STAFF REPORT
WEST ALLIS PLAN COMMISSION
Wednesday, June 28, 2023
6:00 PM

3. Site, Landscaping, and Architectural Design Review for Eye Care Specialists Clinic, a proposed Medical Clinic, at 10200 W. National Ave. (Tax Key No. 485-9990-013)

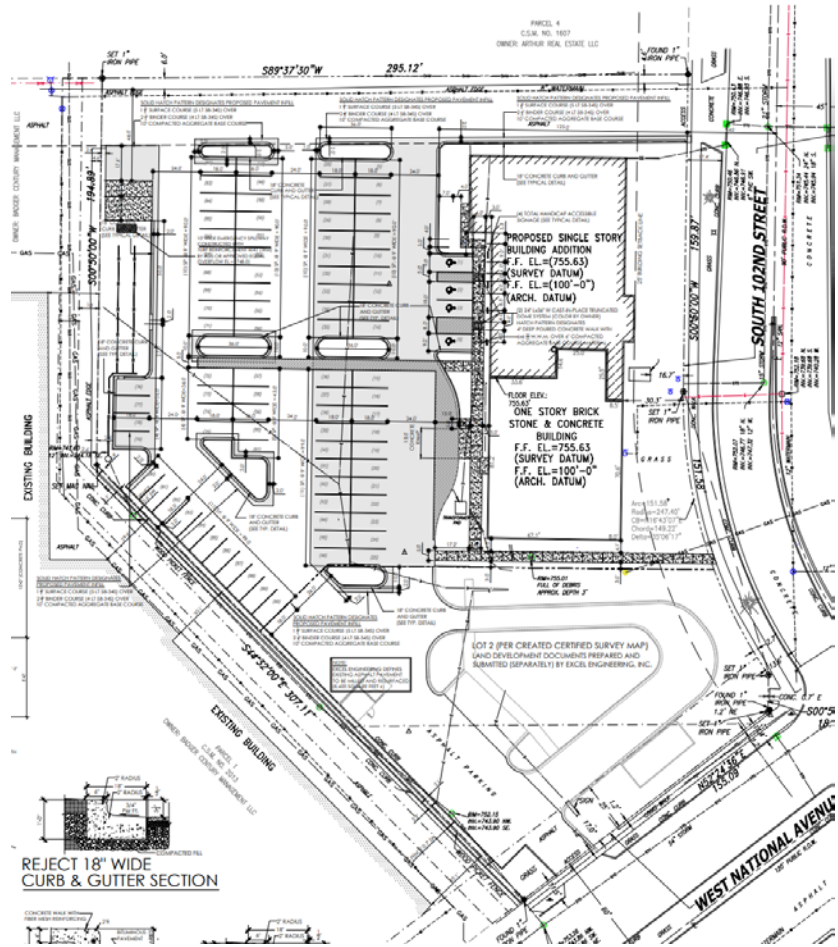
The parking lot includes significant changes from the site's original layout. This portion of the existing site currently has 113 parking spaces. A maximum of 67 spaces are allowed for a 13,300 sq. ft. medical clinic. The number of vehicle parking spaces on this portion of the site will be reduced from 113 to 90; a reduction in nonconformity that can be approved by Plan Commission. This figure was agreed upon between staff and the applicant; it satisfies the Ophthalmic Construction Consulting Firm's recommendation for 1 space per 150 sq. ft. of clinic space.

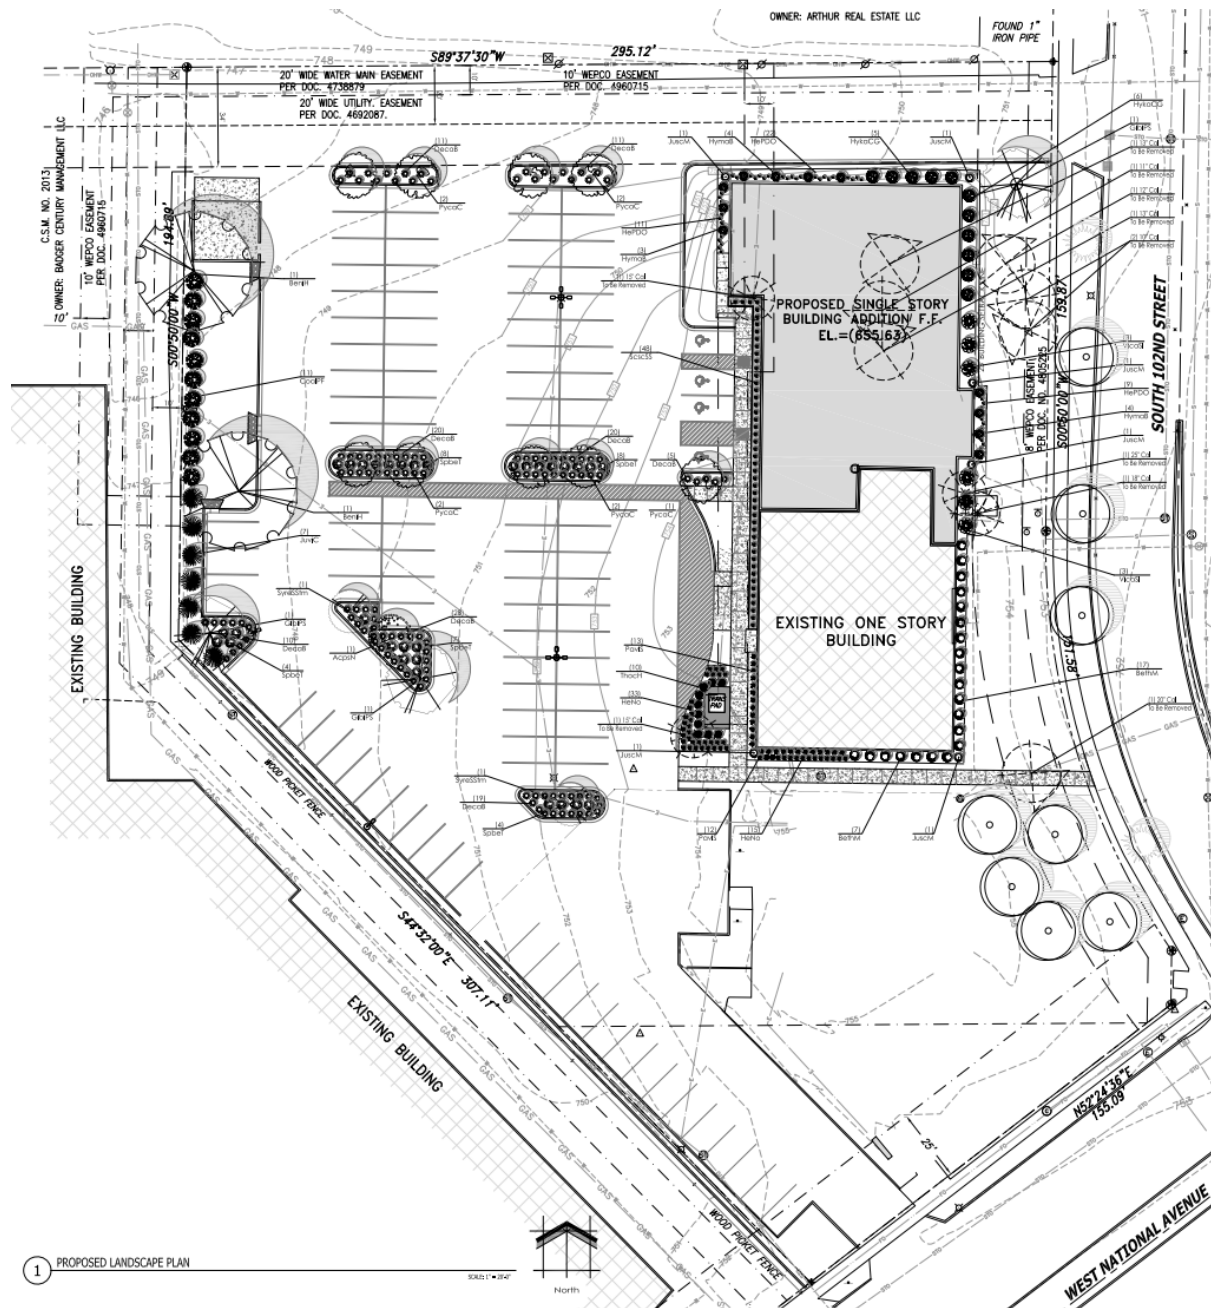
The parking lot also includes the addition of landscaping islands. 2 will be placed on the north edge of the property to better buffer the lot from the alley shared with Target, Piggly Wiggly, and others. Staff recommends the central landscaping islands be modified so that the pedestrian walkway be centered between 2 portions of landscaping, rather than alongside and potentially blocked by misparked vehicles. Landscaping and a refuse enclosure will be added along the west lot line.

Other features include pedestrian connections with a sidewalk along the west edge of the building that connects to sidewalk from the proposed development to the south and S. 102nd St. along the south edge of the building. Additionally, the site includes a drive-up pick-up/drop-off near the entrance; an important feature as some patients may be unable to drive themselves to or from the clinic. The site requires 1 outdoor bicycle parking space; none are proposed. Staff recommends adding 1 outdoor bicycle rack.

3. Revisions to Site, Landscaping, and Architectural plans showing a) addition of one (1) bicycle parking rack; b) addition of a bench near the front entrance; c) align sidewalk to meet Caribou Coffee's along the south property line; d) realign mid-parking lot landscaping islands and pedestrian walkway so the sidewalk runs through the landscaping island.
